E Renfro QuikTrip – Site Plan

Site Plan with waivers
(22-106)

Waivers requested:

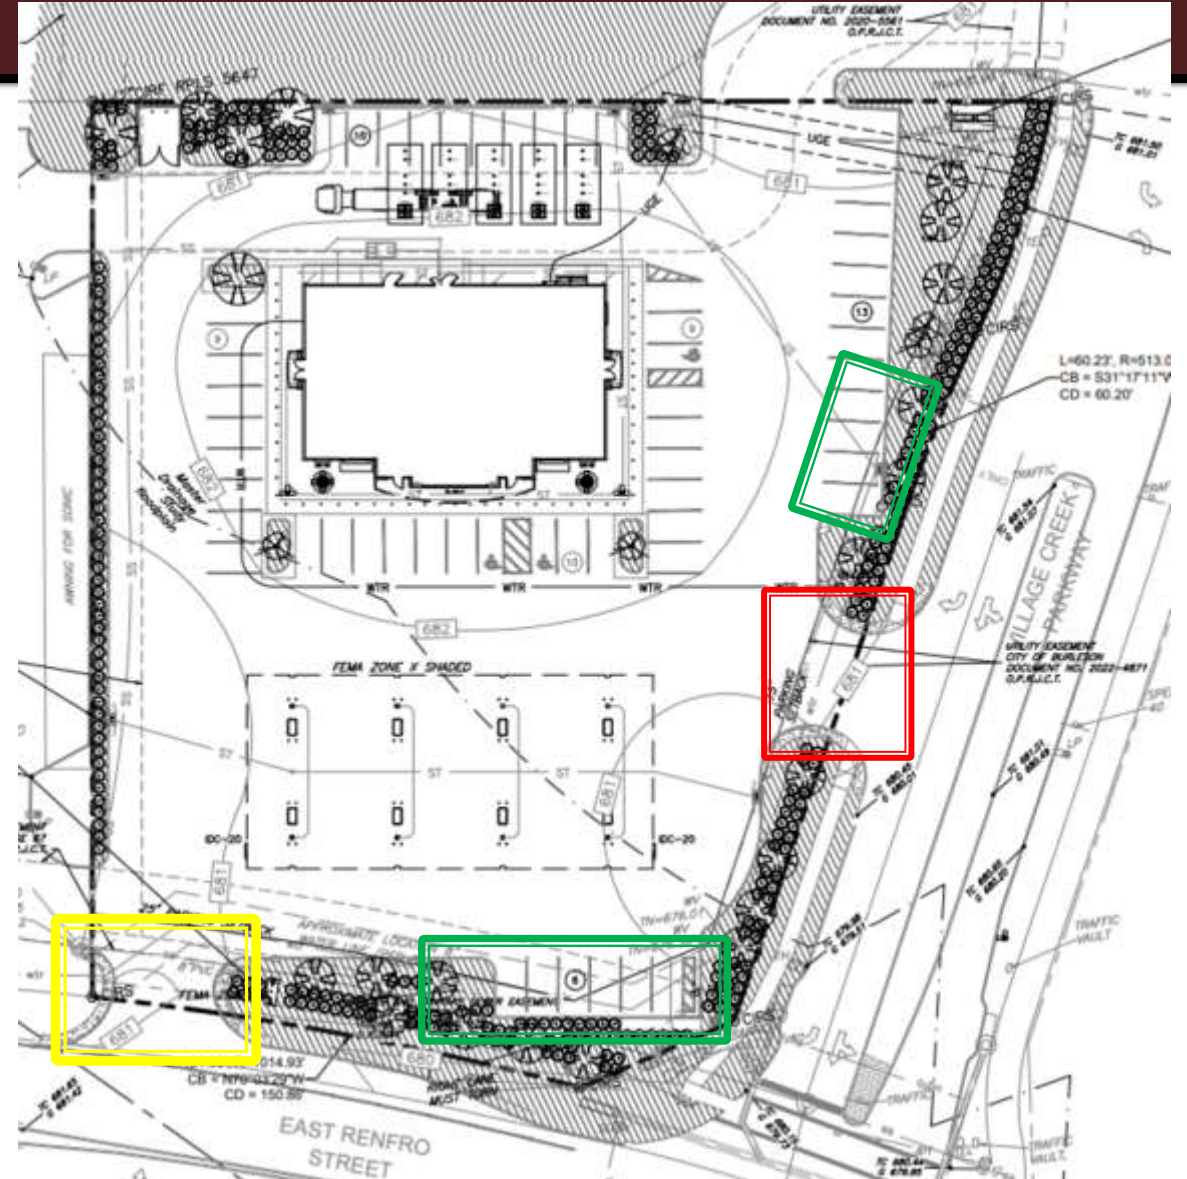
- Parking setback of 25 ft. along E Renfro and 15 ft. along Village Creek Pkwy (IH35 overlay requirement)
- Staff supports - Parking spots will be landscaped between headlights and street (shown in green)
- Drive (access) spacing of 200 feet.[Engineering Design Manual requirement] along Village Creek Pkwy
- Staff does not support reducing the minimum required spacing from 200 ft. to 123 ft., based on proximity to E Renfro and existing access to the site (shown in red)

A separate variance request has been submitted to TxDot (shown in yellow) for E Renfro

Recommend approval of a commercial site plan with a waiver to the IH35 parking setback requirement (Case 22-106).

Recommend disapproval of the request for a waiver to the driveway spacing requirement along Village Creek Pkwy.
